**ALTERATION TO A HISTORIC PROPERTY STAFF REPORT**

Site / District(s)	24 Pleasant Avenue	circa 1875 J. Frank Wellington House
Case:	HPC 2013.053	Pleasant Avenue Local Historic District
Applicant Name:	Susan Kamin, Owner	
Applicant Address:	24 Pleasant Avenue, Somerville MA	
Date of Application:	August 14, 2013	
Legal Notice:	<i>Replace roofing material.</i>	
Staff Recommendation:	<b>Certificate of Hardship</b>	
Date of Public Hearing:	September 17, 2013

24 Pleasant Avenue, August 2013

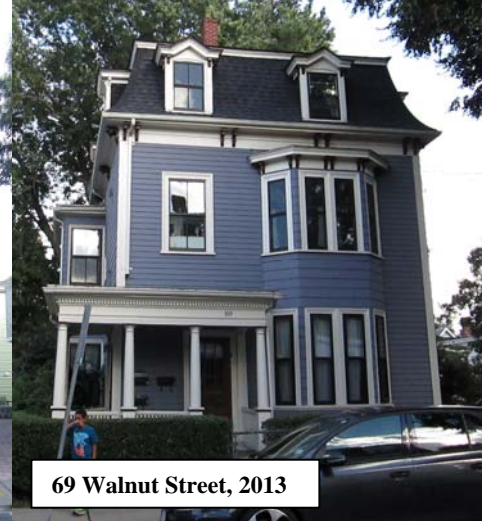
- *What is the visibility of the proposal?* This roof and chimneys are extremely visible on the main façade of the house and from Vinal Avenue.
- *What are the Existing Conditions of the building / parcel?* The work is already underway. The roof had been 3-tab asphalt shingle. The Applicants made their choice of Timberline based on price, and color. They had seen several houses in the neighborhood, including Mansards, with similar style roofs and believed that it was just a replacement in-kind. The contractor is Quality Roofing by Larry. One of the partners was on vacation when the contract was signed and it somehow got missed when he came back. It was clearly in the contract for them to get the permit and they have apologized to the Applicants.

The mortar is beginning to fail and the chimneys are leaning slightly. This is a good time to rebuild the chimneys and to re-flash them.

The removal of a chimney will alter the perception of the building making it more difficult to understand the building.

The removal of a chimney is the removal of a character-defining feature. The chimneys should be rebuilt rather than removed.

The chimney style should replicate the existing with reused bricks and appropriate mortars.

For the chimneys, any needed replacement bricks should match the existing in color, texture, form and other visual qualities. The mortar should match the existing to ensure that no bricks are damaged in the reconstruction.
